## DEVELOPMENT FACILITATION TEAM

### Planning - Case Comments

**Project Number:** PR-2023-009368

**Project Name:** Farolito Senior Community

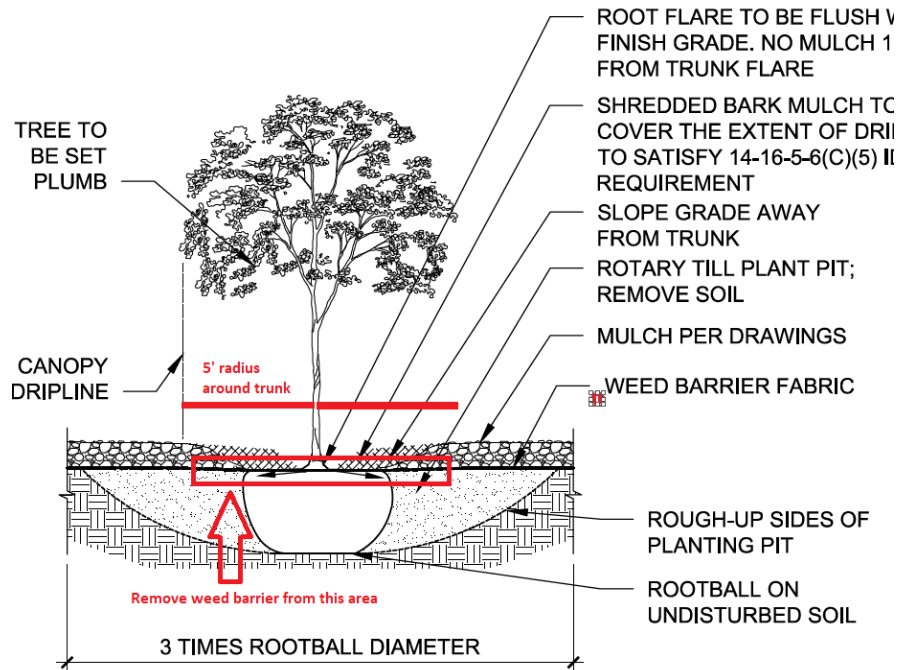
**-Repalce the Raywood ash with Urbanite Ash, Autumn Blaze maple with Bigtooth maple, and Austrian Black pine with Italian Stone pine.** Addressed-DPS.

**-Change the trees under the overhead distribution line along the north edge of the project to Golden rain trees and Russian hawthorns.** Addressed, planting was arranged to meet new plant sizes.

**-Of the two different locust trees you have proposed, choose one type only and spread them in the site so no two locust trees are adjacent to one another, because of the appearance of the beetle that has been killing locust trees.** Addressed, all Locusts are now Purple Robe Locusts, none are next to each other- DPS.

**-Please be aware that Purple Robe locust requires structural pruning. Also, fruit trees are prone to frost damage (especially fig trees). Please add a comment to reflect that if any of the proposed trees die off at any time, they will be replaced with new ones.**  
**-If you have any questions regarding these comments, please contact Bonnie Strange, Senior Planner at the Urban Forestry at [bstrange@cabq.gov](mailto:bstrange@cabq.gov).**

A general note was added to address the locusts, as for the fruit trees, this client specifically requested an orchard on the property for their residents. They have prepared for the proper care and maintenance required. A general note was included for this -DPS
